**ENERGY  
NORTHWEST**

August 17, 2007  
GO2-07-128

**COLUMBIA GENERATING STATION, DOCKET NO. 50-397  
RESPONSE TO REQUEST FOR ADDITIONAL INFORMATION  
RELATED TO REQUEST FOR EMERGENCY PLAN CHANGE**

**RESPONSE TO REQUEST FOR ADDITIONAL INFORMATION RELATED TO  
REQUEST FOR EMERGENCY PLAN CHANGE**

**Figure 3-1, Outside Response Agency Resources**

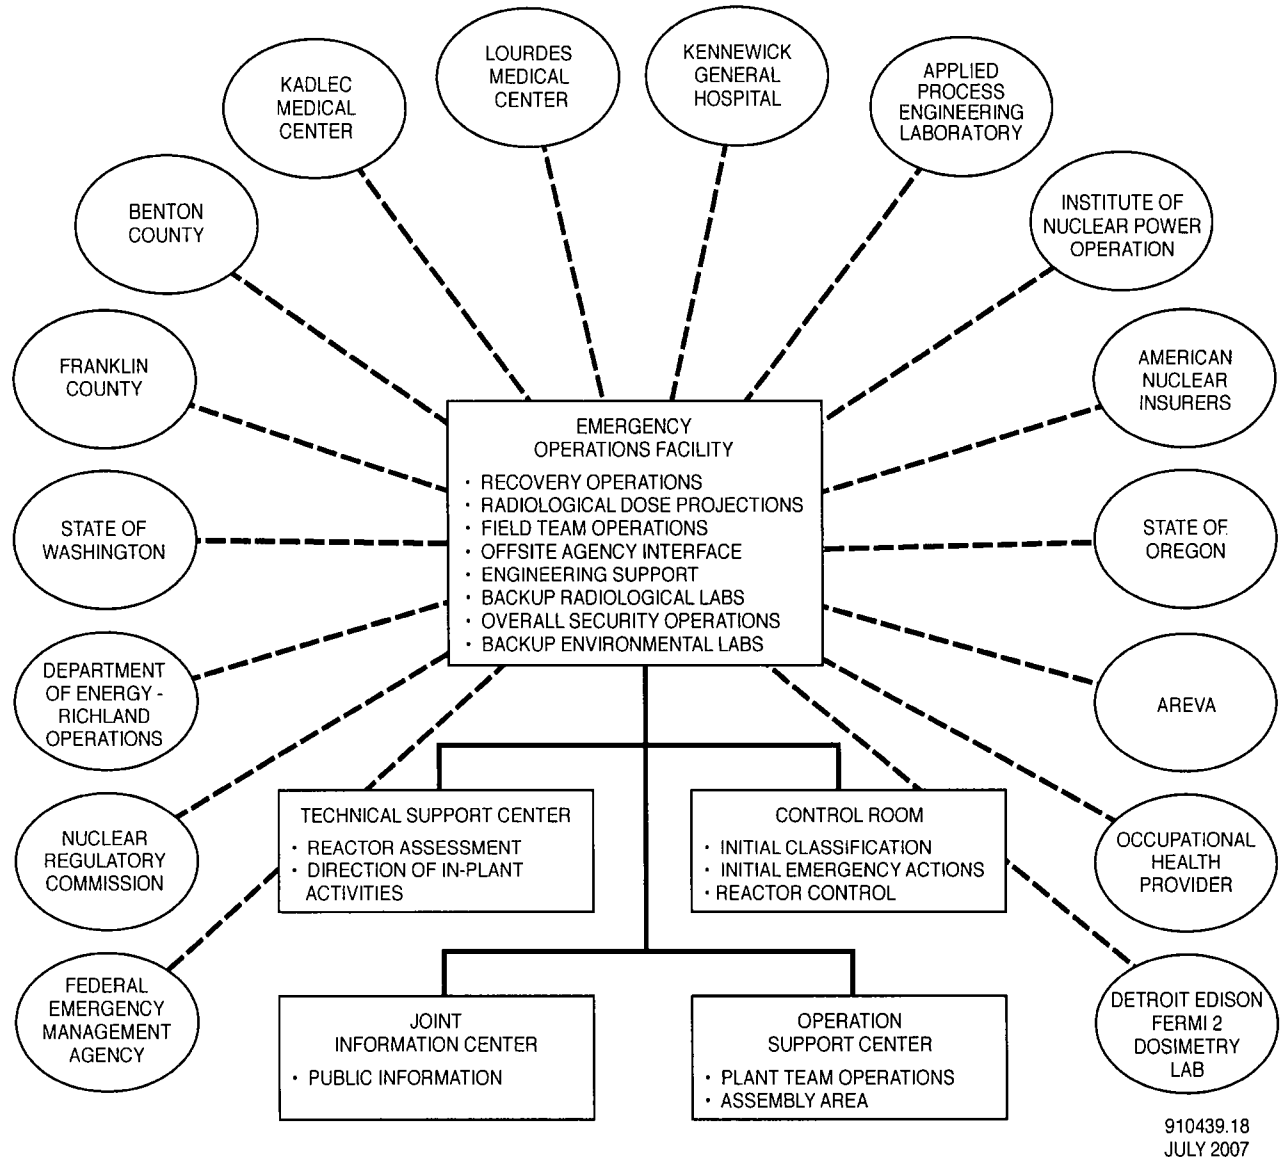
8. *In the proposed change to Figure 3-1, no mention of the backup environmental laboratory is designated. Please explain.*

This information has been added to the figure, provided in attachment 2.
